Access Compliance Report

Public Rights-of-Way

Intersection ID: 51481	Main Street: KRISTENS_MARE_DR	Cross Street: ARDWYCK_PL	Location: W
ADA ID: 50A16E7A11AE	Ramp Type: PerpDiag	Initial Pass/Fail: Pass	Overall Compliance: No
Severity Score: 5			
Codes/Mitigation Info/Possible Solution		Field Measurements/Component Compliance

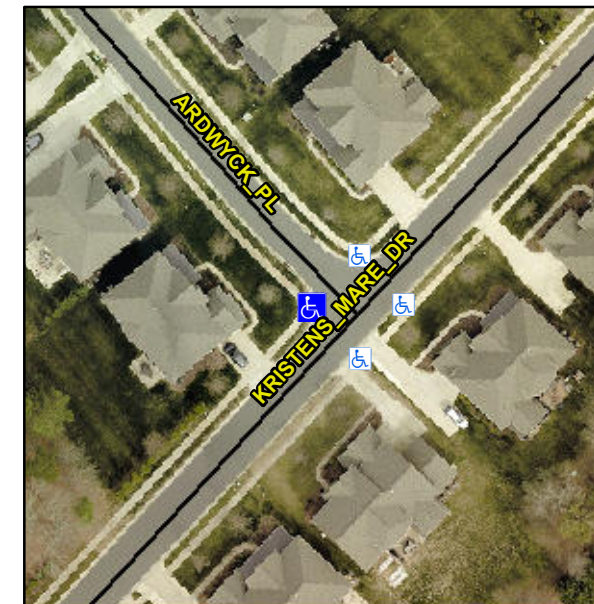
Not Found, R304.2.1, R304.5.3, R305.2, R304.5.4

Compliance	Description	Data	Compliance	Description	Data
N/A	Ramp Length (in)	50.0	Yes	Ramp Slope (%)	6.3
Yes	Ramp Width (in)	48.0	Yes	Ramp XSlope (%)	1.8
N/A	Flare Type LT	Sloped	N/A	Flare Type RT	N/A
N/A	Flare Slope LT (%)	5.5	Yes	Flare Slope RT (%)	3.7
N/A	Flare Traversable LT?	Yes	N/A	Flare Traversable RT?	Yes
No	Landing Length (in)	43.0	Yes	DWS Provided?	Yes
Yes	Landing Width (in)	48.0	Yes	DWS Contrast?	Yes
Yes	Landing Slope (%)	1.5	Yes	DWS Length (in)	24.0
No	Landing X Slope (%)	2.3	Yes	DWS Full Width?	Yes
N/A	Landing Curb? (Y/N)	No	No	DWS Offset (in)	5.0
N/A	Shared Landing?	No			
Yes	Gutter Ponding?	No	No	Gutter Slope (%)	6.1
Yes	Gutter Lip Ht (in)	0.0	Yes	Gutter X Slope (%)	0.4
N/A	Painted X Walk1?	No	N/A	Painted X Walk2?	No
	X Walk 1 Direction	To SE		X Walk 2 Direction	To NE
N/A	X Walk 1 Width (in)	N/A	N/A	X Walk 2 Width (in)	N/A
	X Walk 1 Slope (%)	3.2		X Walk 2 Slope (%)	1.1
	X Walk 1 X Slope (%)	0.3		X Walk 2 X Slope (%)	1.8

N/A	Ramp inside XWalk1?	N/A	N/A	Ramp inside XWalk2?	N/A
	Road Slope (%)	1.9	N/A	Clear Space?	Yes
	Road X Slope (%)	1.0	N/A	Clear Space to XWalk (in)	N/A
Yes	Any Obstructions?	No	Yes	Storm Grate/Utility Hazard?	No
	Obstruction Type			Storm Grate/Utility Type	
		N/A			N/A
			Yes	Surface Condition? (G/P)	Good

Remove & Replace Curb Ramp With Two New Directional Ramps or Equivalent. Remove & Replace Gutter.
